ADDENDUM NUMBER 2 – JULY 22, 2024

AUGUSTA REGIONAL LANDFILL – LFGCCS EXPANSION

SOLID WASTE PERMIT NO. 21 AND NO. 585

Prospective Bidders are hereby advised of the following revisions to the Bid Documents for the subject Project:

SHEET TITLE: SWP #585
 PROPOSED GCCS DESIGN LAYOUT
 PROJECT TITLE: AUGUSTA REGIONAL LANDFILL
 GCCS DESIGN AND EXPANSION

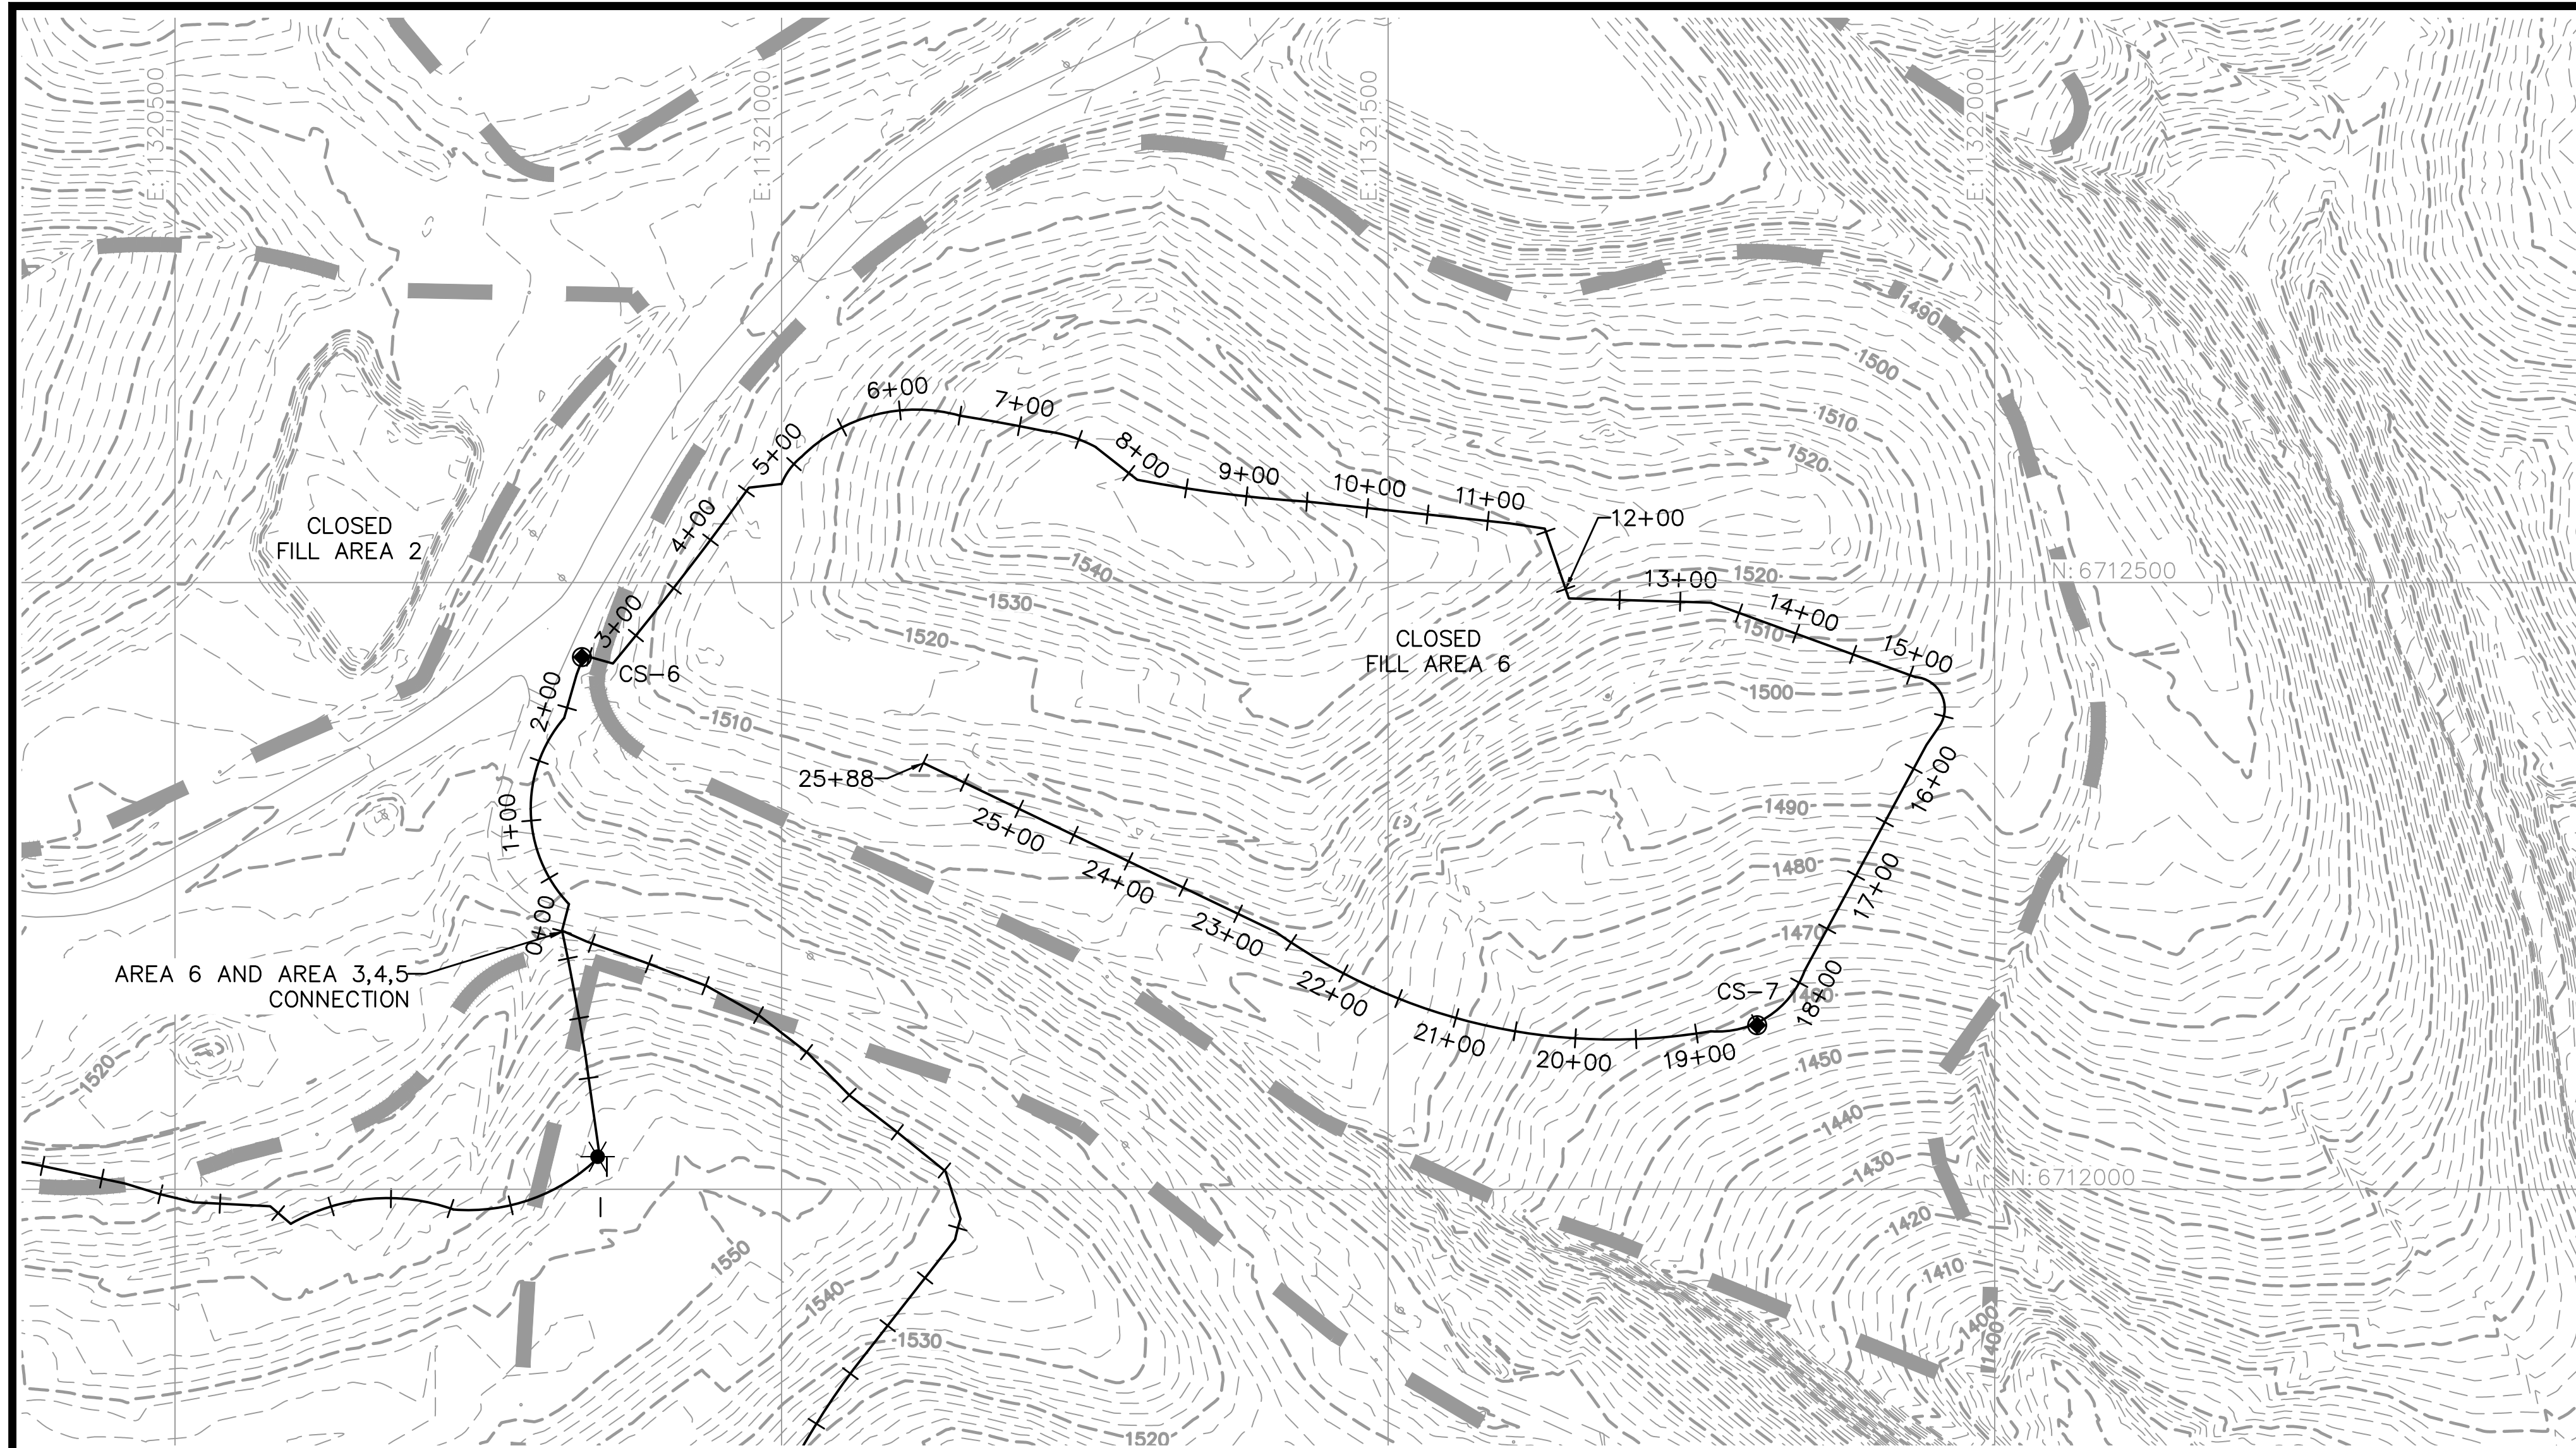
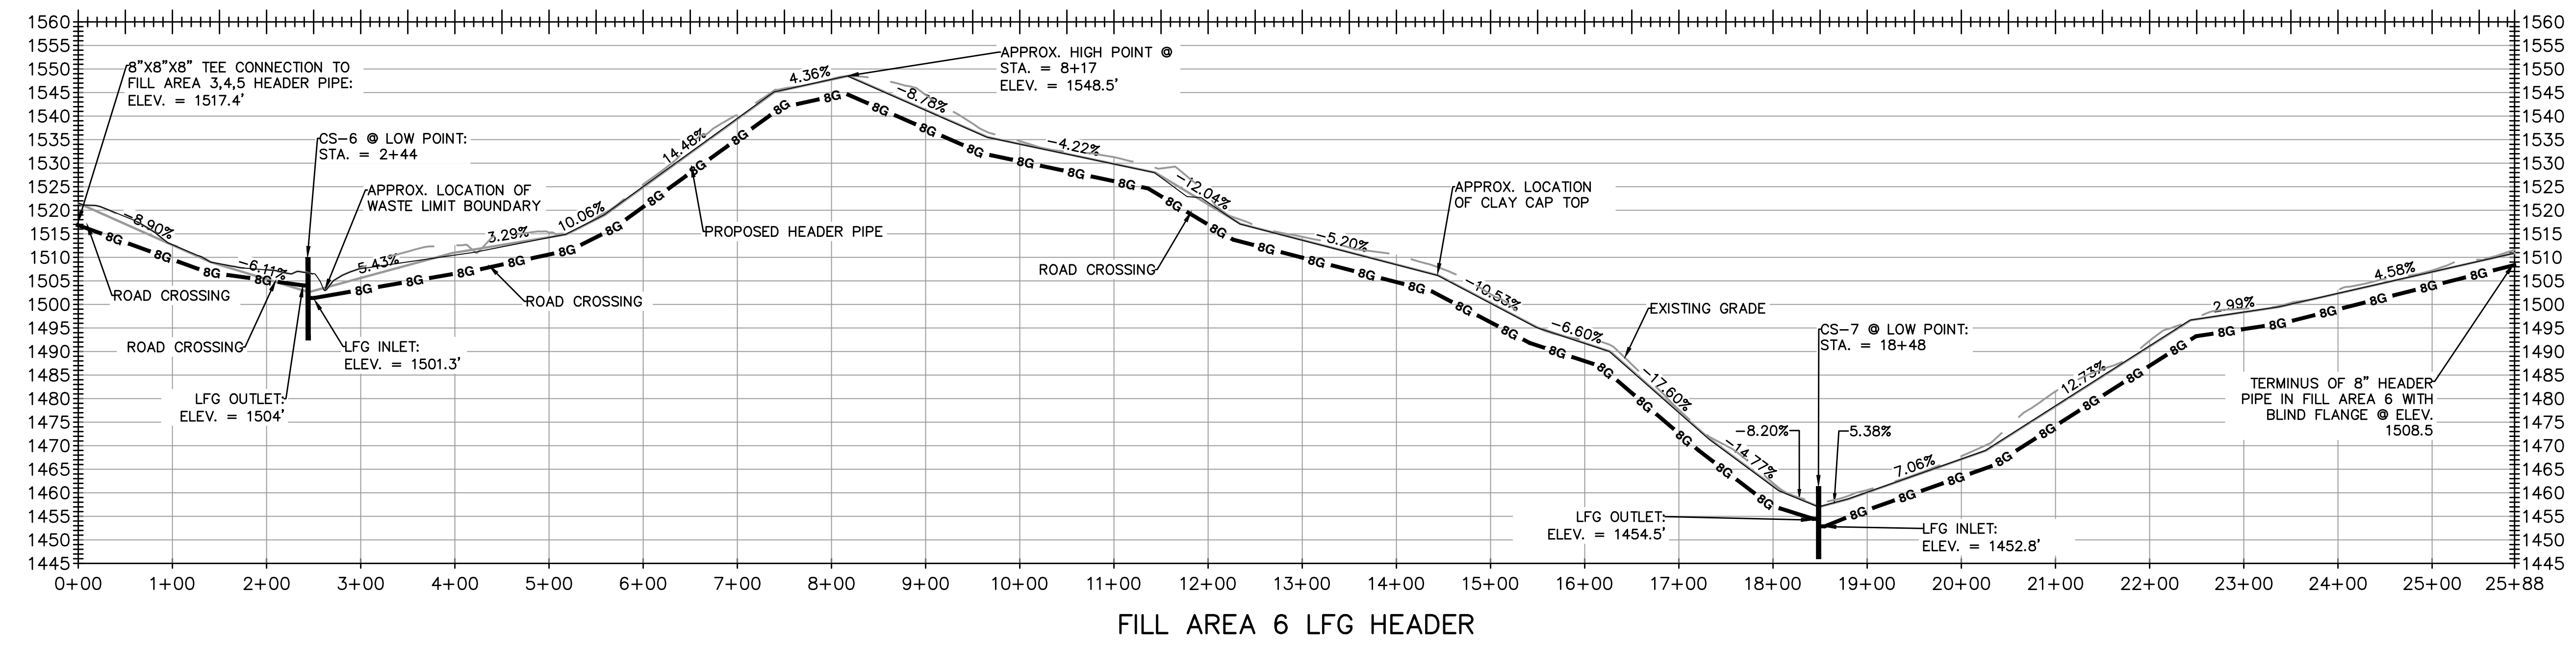
Question 11: Extraction Well 25 on Sheet No. 6B is labeled as an Extraction Well, but has a symbol for a remote well. Is Extraction Well 25 an extraction well or a remote well?

Question 16: If the constructed alignment of the landfill gas collection piping in Phase 4 of Solid Waste Permit No. 585 differs from the conceptual alignment on Sheet No. 6B, will the selected contractor be paid for these modifications?

Answer: Remote wells are extraction wells that utilize a construction technique in which the wellhead is located upgradient of the well as shown in Detail 3 on Sheet 10. Accordingly, Well 25 should be drilled where the remote well symbol is shown, and its wellhead installed adjacent to the 8-inch landfill gas collection piping. This technique allows condensate that builds up in the 4-inch collection piping to drain back into the extraction well without the use of an additional sump. The 4-inch collection piping for a remote well should be placed at a minimum 4% slope so that liquids drain

from the wellhead to the extraction well. The wellhead should be at an elevation above both the 8-inch collection piping and the extraction well. Except for the change in wellhead location and connection arrangement, the drilling and construction of a remote well should be the same as any other extraction well. Bidders should be familiar with the conditions which necessitate a remote wellhead installation and the construction methods used for a remote well.

Answer: Bidders should anticipate making modifications to the proposed alignment to maintain the required landfill gas collection system slopes at no additional cost to the owner.
